**[Docket No. FAA–2017–0288; Product Identifier 2017–CE–007–AD; Amendment 39–19231; AD 2018–06–11]**

#### Airworthiness Directives; Textron Aviation Inc. Airplanes

**ACTION:** Final rule.

**SUMMARY:** We are adopting a new airworthiness directive (AD) for certain Textron Aviation Inc. Models A36TC, B36TC, S35, V35, V35A, and V35B airplanes. This AD was prompted by a fatal accident where the exhaust tailpipe fell off during takeoff. This AD adds a life limit to the exhaust tailpipe v-band coupling (clamp) that attaches the exhaust tailpipe to the turbocharger and requires an annual visual inspection of the exhaust tailpipe v-band coupling (clamp). We are issuing this AD to address the unsafe condition on these products.

Figure 1 to paragraphs (k)(1)(iii) and (v) of this AD: Cross section of v-band coupling

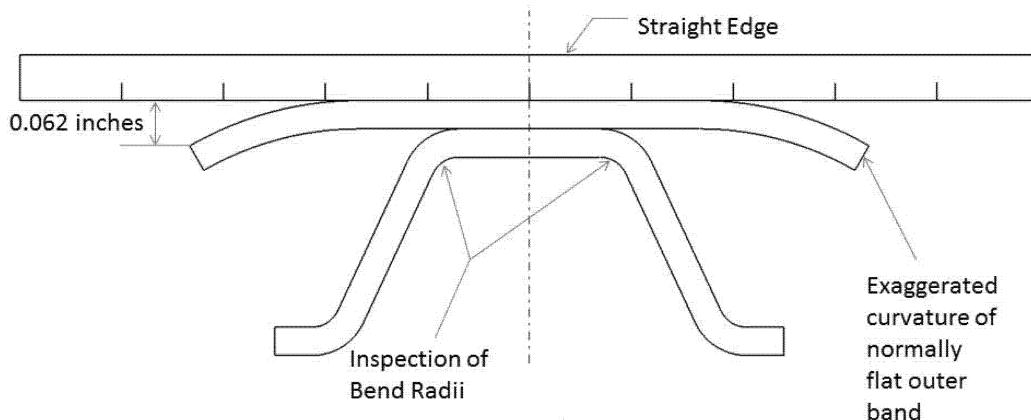
(iii) Visually inspect the flatness of the outer band using a straight edge. Lay the straight edge across the width of the outer band. The gap must be less than 0.062 inches. See figure 1 to paragraphs (k)(1)(iii) and (v) of this AD. If the gap exceeds 0.062 inches between the outer band and the straight edge, do not re-install the v-band coupling. Before further flight, you must install a new v-band coupling and restart the hours TIS for the repetitive replacement of the v-band coupling.

(v) Visually inspect the bend radii of the coupling v-retainer coupling segments for cracks. Inspect the radii throughout the length of the segment. See figure 1 to paragraphs (k)(1)(iii) and (v) of this AD. If any cracks are found, do not re-install the v-band coupling. Before further flight, you must install a new v-band coupling and restart the hours TIS for the repetitive replacement of the v-band coupling.
